**Board of
Zoning Appeals**

Agenda (AMENDED)

Board of Zoning Appeals
Thursday, April 21, 2022

**STAFF REPORT
BOARD OF ZONING APPEALS
APRIL 21, 2022**

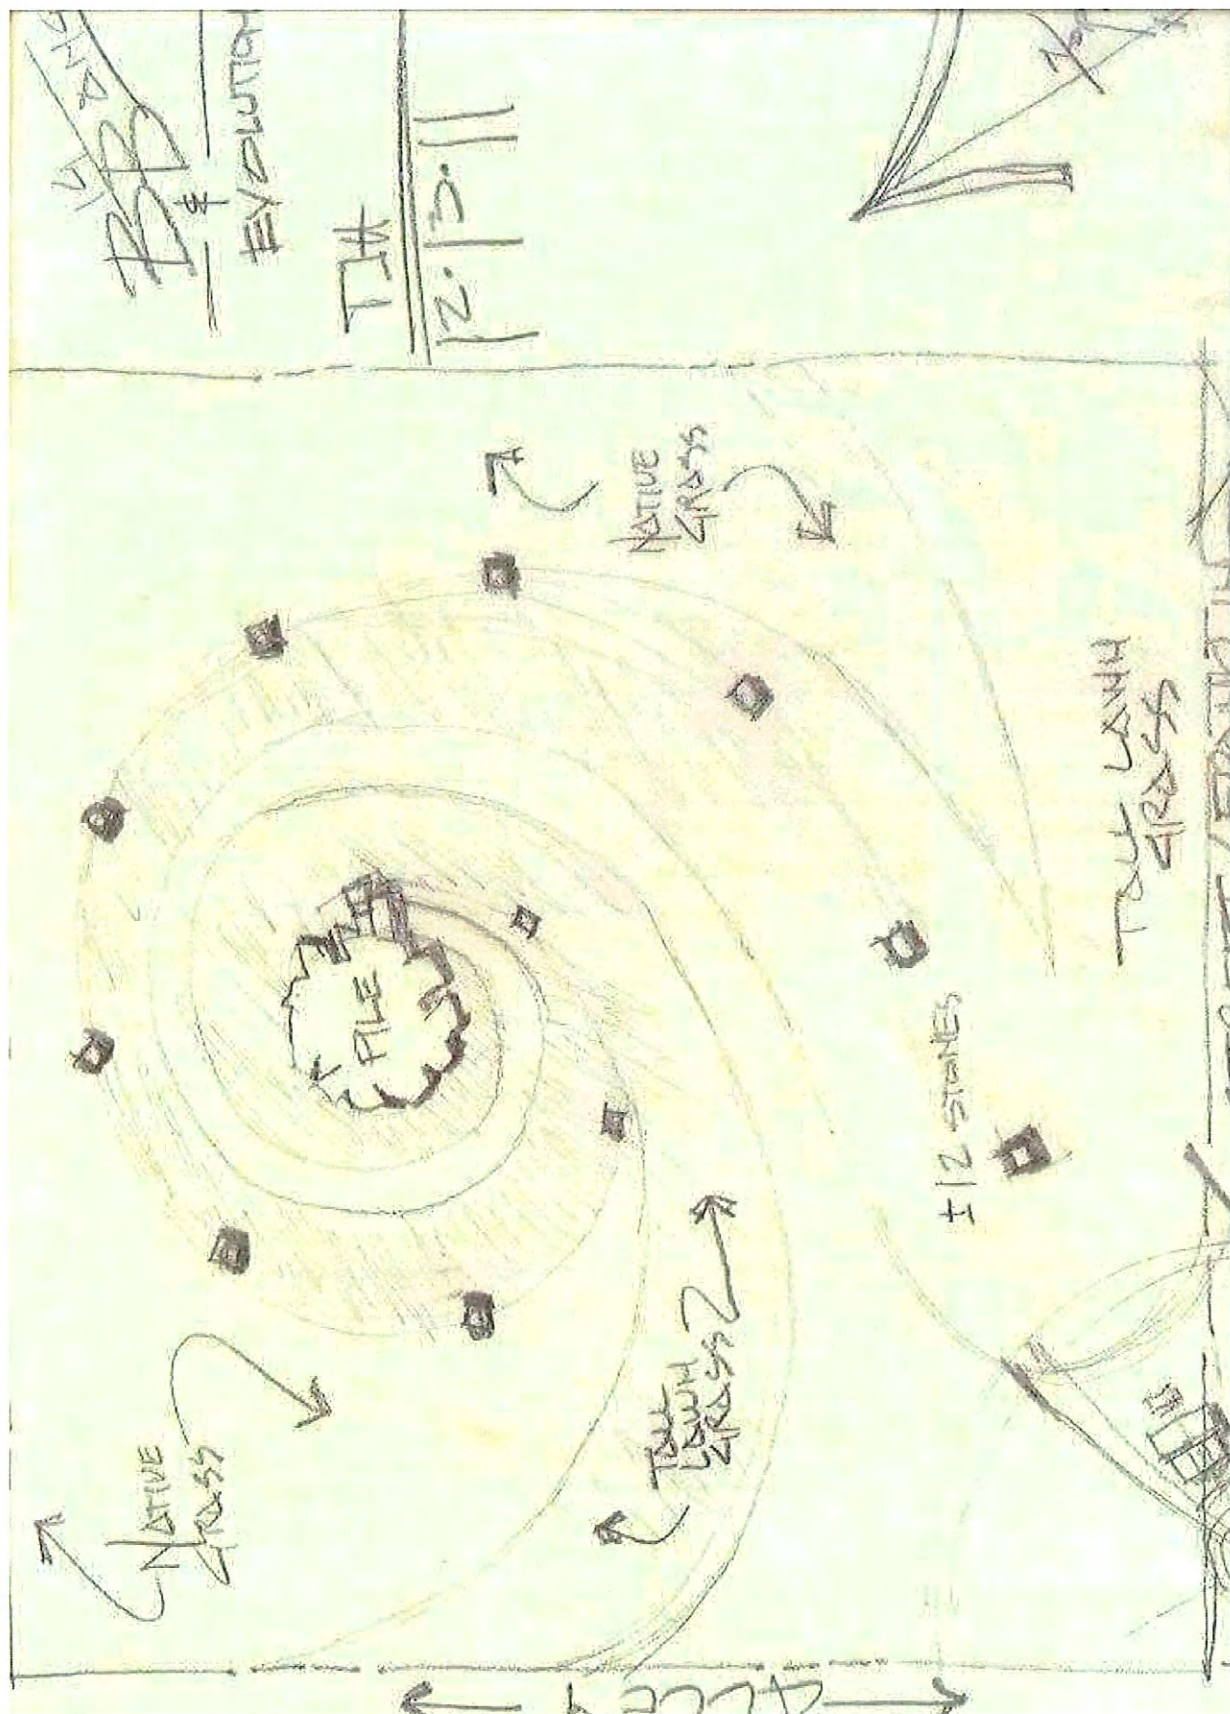
- The plan submitted with this application identifies areas of “nature grass” interspersed with areas of “Tall lawn grass”. Within the tall lawn grass are approximately 12 large stones with a pile of large stones in the middle of the site.

- The City Forester has identified many of the plant species in excess of six inches on site, which are not permitted per the Hilliard Design Manual including wild grapevine, callery pear, poison ivy, sowthistle, marestail, mulberry, honeysuckle, bindweed, clover/oxalis, fox tail grass, walnut, red clover, and dandelion.

- Marestail, bindweed, grapevine, and sowthistle are on the Noxious Weeds List per Ohio Administrative Code section 901:5-37-01.
- Additionally, Ohio Administrative Code Section 901:5-30-01 lists invasive plant species for Ohio. Included in that list are callery pear and honeysuckle, which have both been identified on the site.

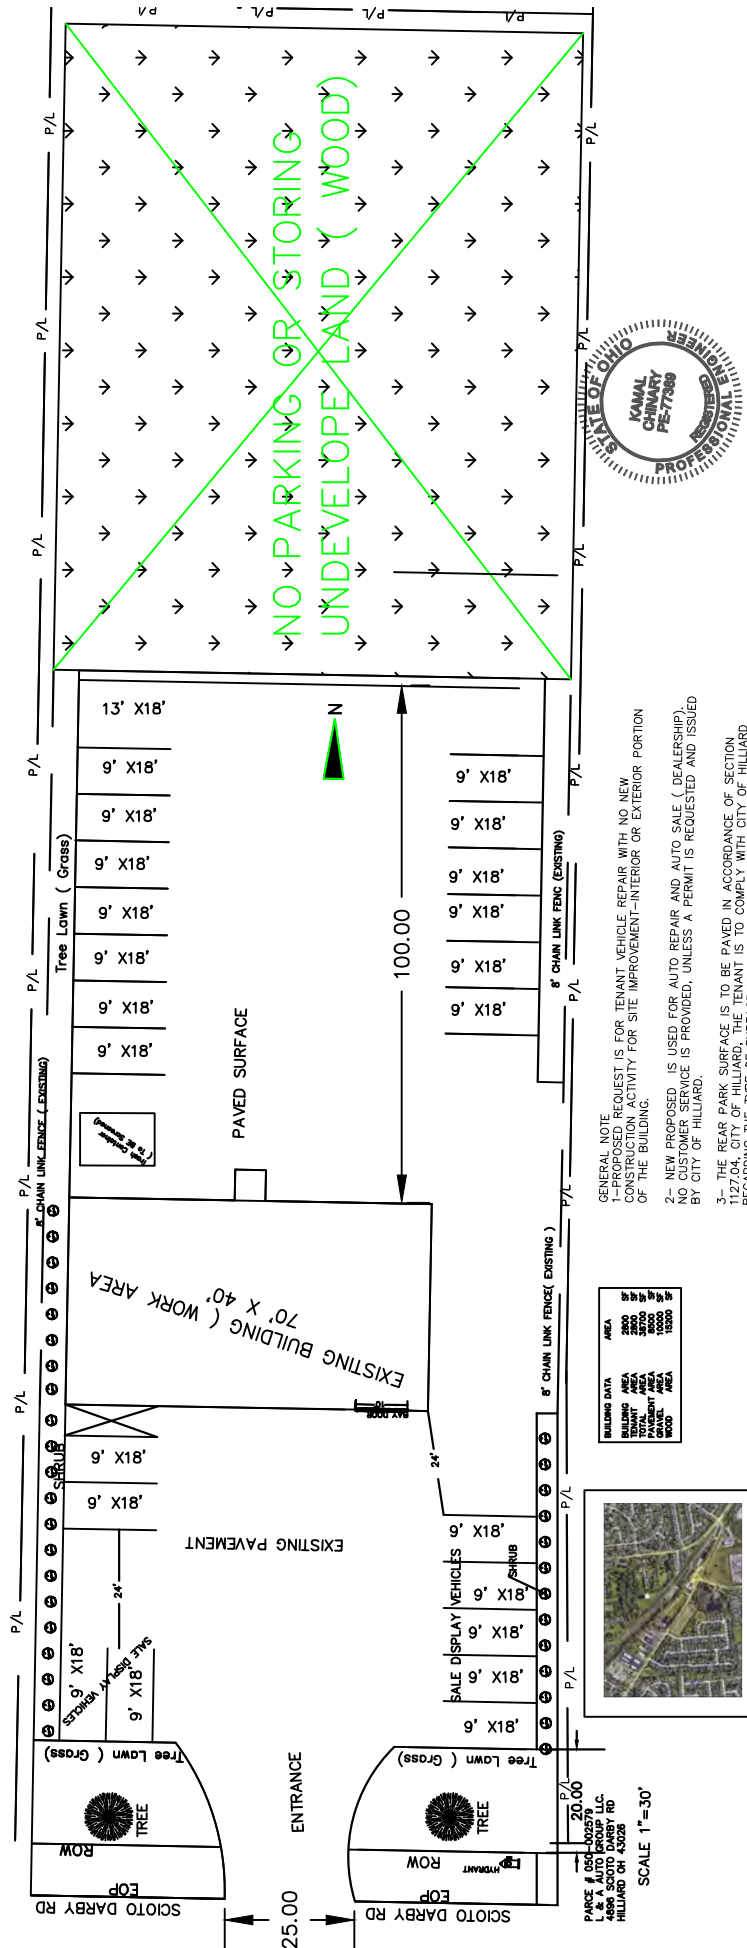
- The site currently has approximately 58 feet of asphalt at the Scioto Darby Road right-of-way line as a driveway entrance. The proposed plan shows that 20 feet of existing asphalt will be removed along the Scioto Darby Road frontage resulting in a 25-foot-wide driveway entrance and a minimum 20-foot pavement setback from the right-of-way line. The proposed plan shows an approximately 10,000-square-foot parking lot expansion on the southeast and northeast sides of the building to the rear.

- The building has one vehicle bay. Hilliard Code Section 1127.03 states that the required parking for a vehicle repair facility is 2 parking spaces per vehicle bay and 1 per employee. The number of employees has not been specified. The proposed plan shows 7 vehicle display parking spaces and two customer parking spaces in front of the building, and 14 parking spaces behind the building. Staff recommends that the hours of operation for this building be limited to between 8:00 a.m. and 8:00 p.m. The outdoor storage of vehicle parts is prohibited.

Staff finds that the existing conditions make it practically difficult to provide vehicular use area perimeter landscaping along the side property lines and vehicular use area interior landscaping per Code without a variance. Staff finds that the proposed variance is not substantial. Staff finds that the essential character of the neighborhood would not be substantially altered as a result of the proposed variance. Staff finds that the variance would not adversely affect the delivery of governmental services. Staff finds that the spirit and intent behind the zoning requirement would be observed and substantial justice done by granting the variance. Based on these findings, consistent with the provisions of Hilliard Code Section 1106.04, staff recommends approval of the proposed variance with the following 6 conditions:

- 1) That all conditions of Planning and Zoning Commission approval on April 14, 2002, are met;
- 2) That the width of the vehicular use area perimeter landscaping along the sides as it exists in front of the building be approved as proposed;

- 3) That the plans are revised to show the vehicular use area in front of the building will have two trees along the Scioto Darby Road frontage and 30 shrubs per 100 linear feet along the entire perimeter;
- 4) That the vehicular use area interior landscaping in front of the building be approved as proposed;
- 5) That the vehicular use area behind the building is not less than 10 feet from the side property lines and is landscaped with 2 trees and 30 shrubs per 100 linear feet consistent with the provisions of Hilliard Code Section 1125.05; and
- 6) That the plans are revised to show the proposed vehicular use area behind the building will conform to the perimeter and interior landscaping requirements specified in Hilliard Code Section 1125.05.
